**City of Paso Robles
Development Review Committee Minutes**

3:30 PM Monday – September 20, 2021

File #: [P20-0075 / GPA20-01 / RZN20-04 / PD20-14 / OTR21-08](#)

Application: The Landing – Estrella Boys School Reuse Plan

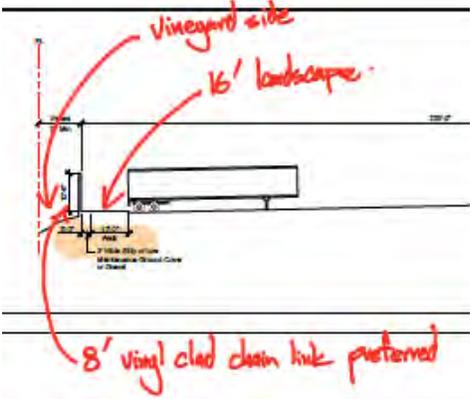
1. Provide additional detail regarding the materials to be used on the Phase 1 warehouse building – i.e., while a painted concrete tilt-up building is proposed, are other materials being introduced to provide additional articulation/interest/accents at the entry, doors/windows, etc.? With that in mind, continue to reduce the overall horizontal nature of the building visually/aesthetically (e.g., remove the color band at the top of the building).
2. To depict the building articulation, add the building in plan to each of the proposed elevations. (See below for an example of format only.) Provide callouts on the elevations (color blocking, scoring).

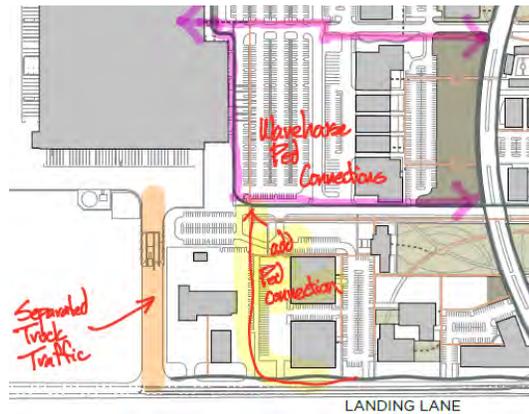
16. Provide a more detailed approach to the Design Guidelines (Guidelines). The Guidelines should provide a comprehensive approach to implementation of the planning, architectural, and landscape architectural concepts for the proposed project. The purpose of the Guidelines is:
 - To provide the City of El Paso de Robles with the necessary assurance that The Landing phases will develop in accordance with the quality and character proposed;
 - To provide guidance to design and construction professionals in order to maintain the desired quality;
 - To provide specific guidance to City decision-makers in the review of future development projects on the subject property; and
 - To formulate concise development guidelines for the various land uses and related built environments within the subject property.
